DaimlerChrysler India Private Limited

Suppliment to recently launched below mentioned Service Measures

ANNEXURE I

ANNEXURE II

Figure 1

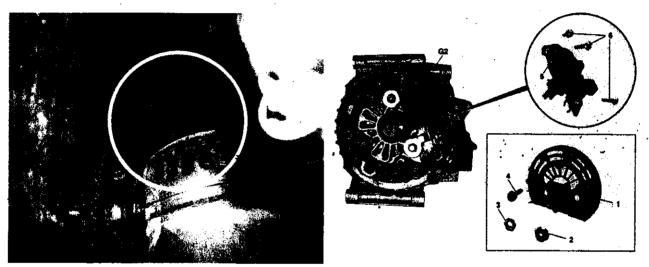
- 1. Connect the Diagnosis Assistance System (DAS) and perform a quick test.
- I Only Bosch alternators are installed for M 113 engines, thus it is not necessary to check for the manufacturer. The regulator can be immediately replaced.
- 2. Check alternator manufacturer model (M 112 only, from top with mirror, Fig. 1)
 - a Additional work is not required for the Valeo alternator.
 - **b** For the Bosch alternator, see work procedure.
